RFB NO. 313086 - ADDENDUM NO. 6

### ARCTIC ANIMAL EXHIBIT AND CONCESSIONS

This Addendum is issued to modify, explain or clarify the original Request for Bid (RFB) and is hereby made a part of the RFB. Please attach this Addendum to the RFB. **Bidders must acknowledge all Addenda on the Bid Form.**

S7.4

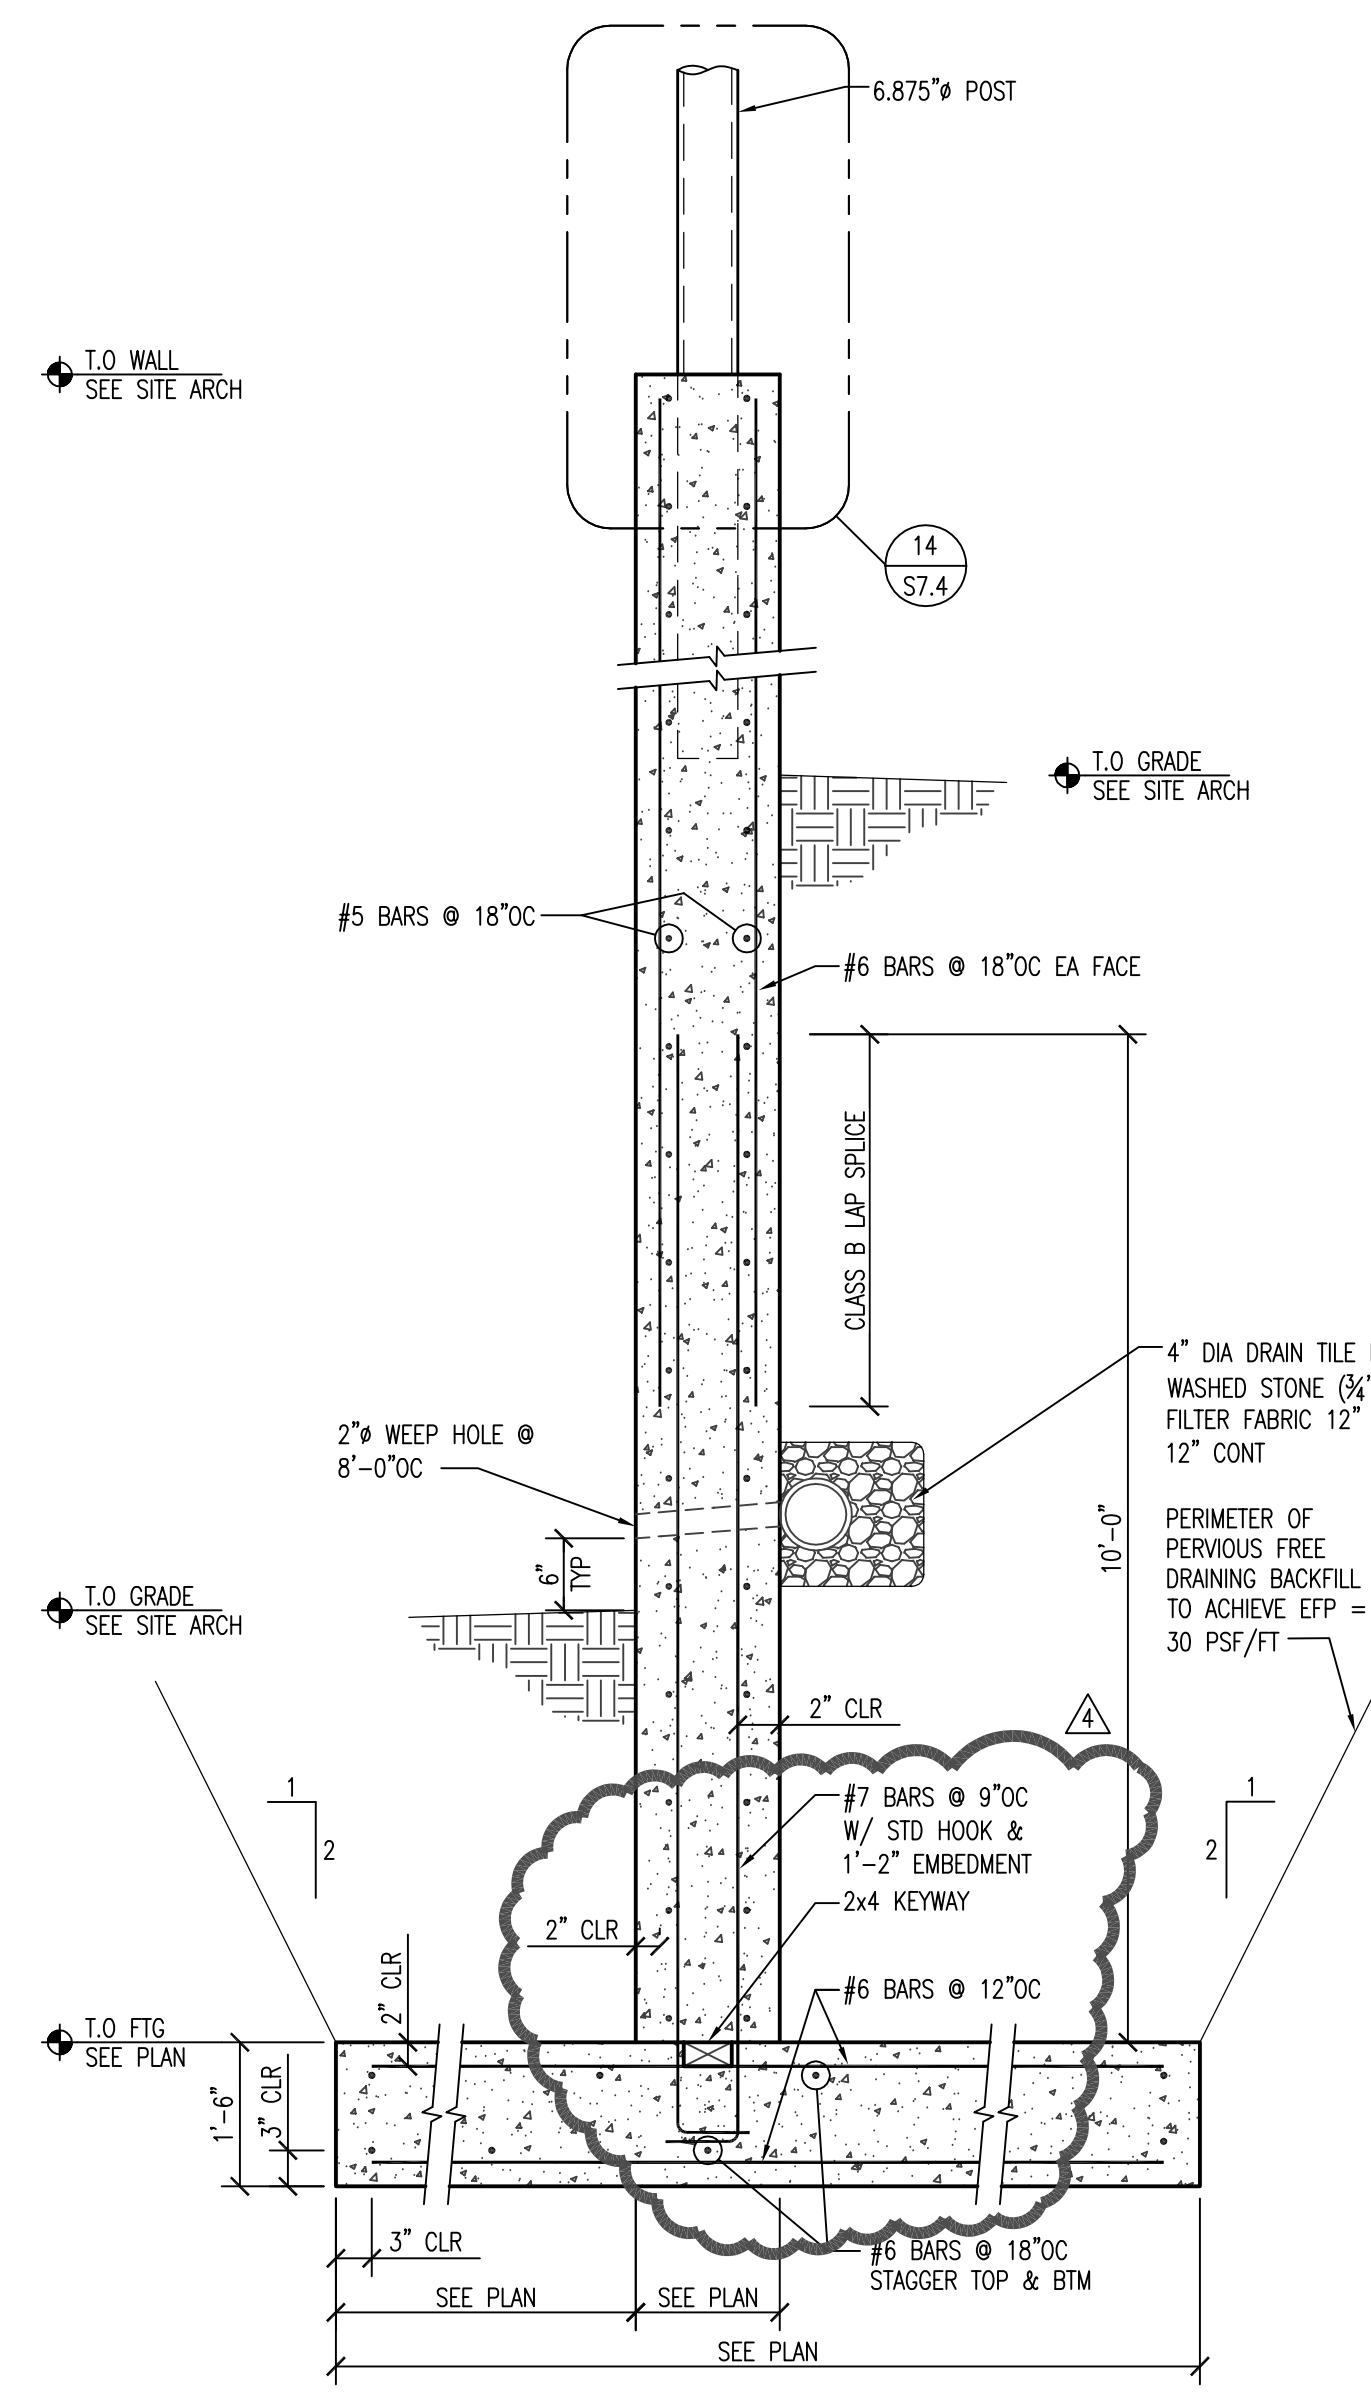
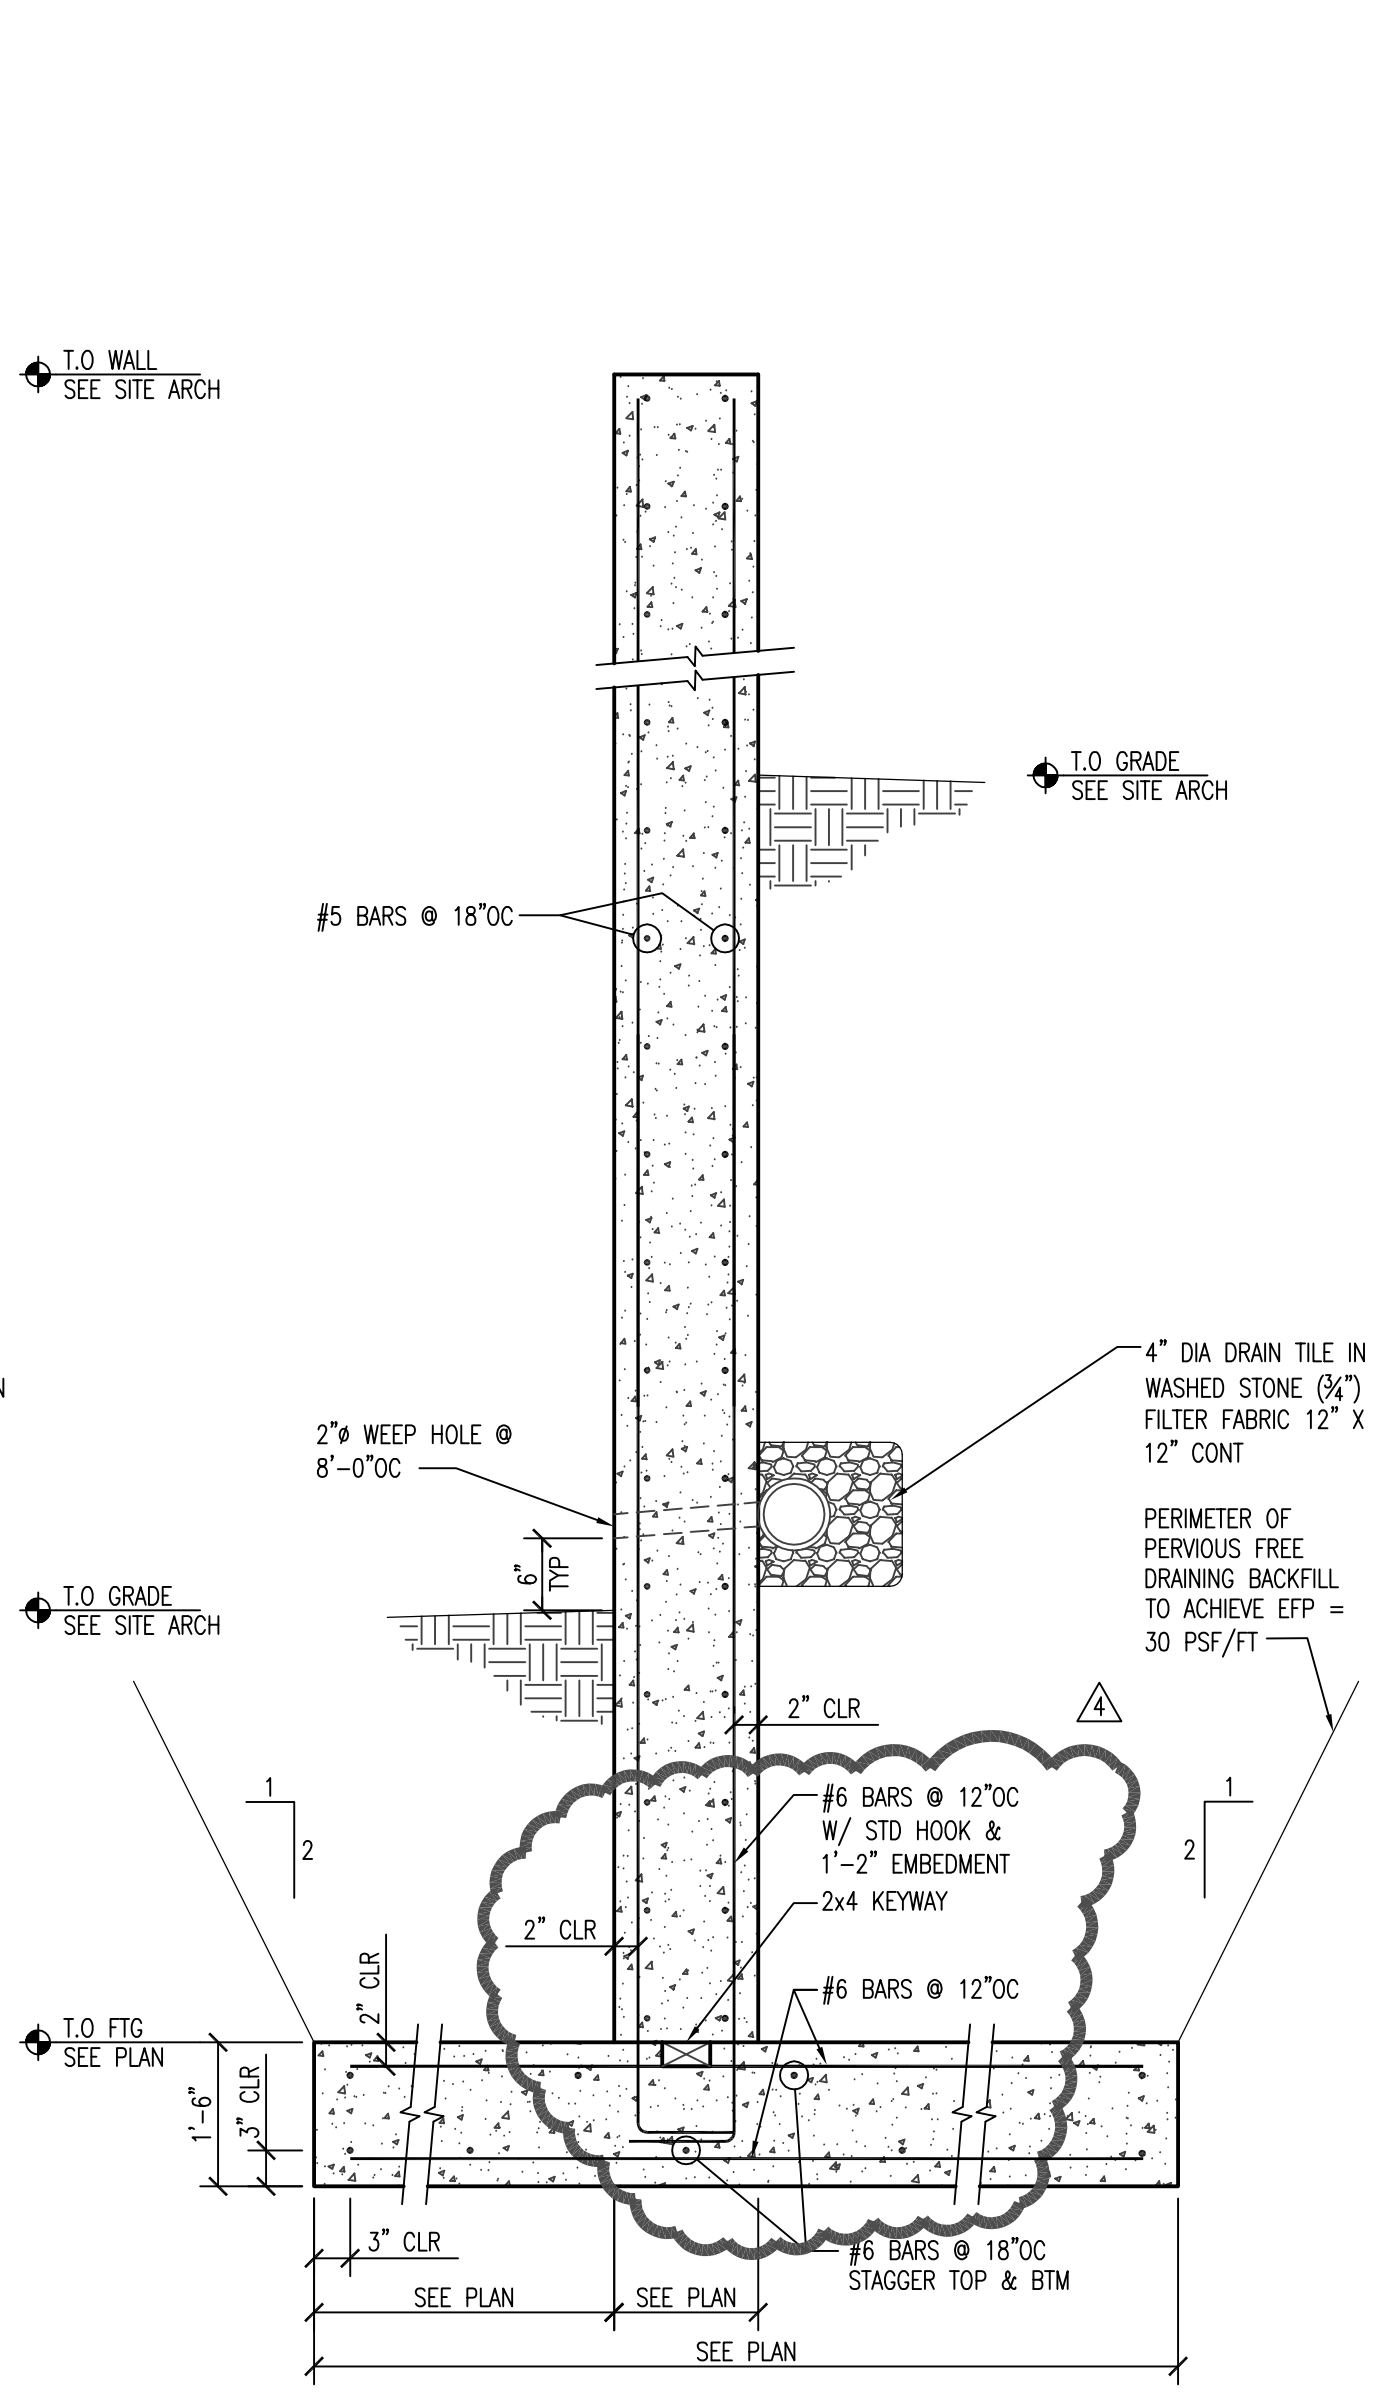
### **32. Sheet S7.4- Foundation Details**

- Detail 6: Added 1'-2" embedment note and adjusted rebar in footing
- Detail 7: Added 1'-2" embedment note and adjusted rebar in footing
- Detail 9: Added 1'-2" embedment note
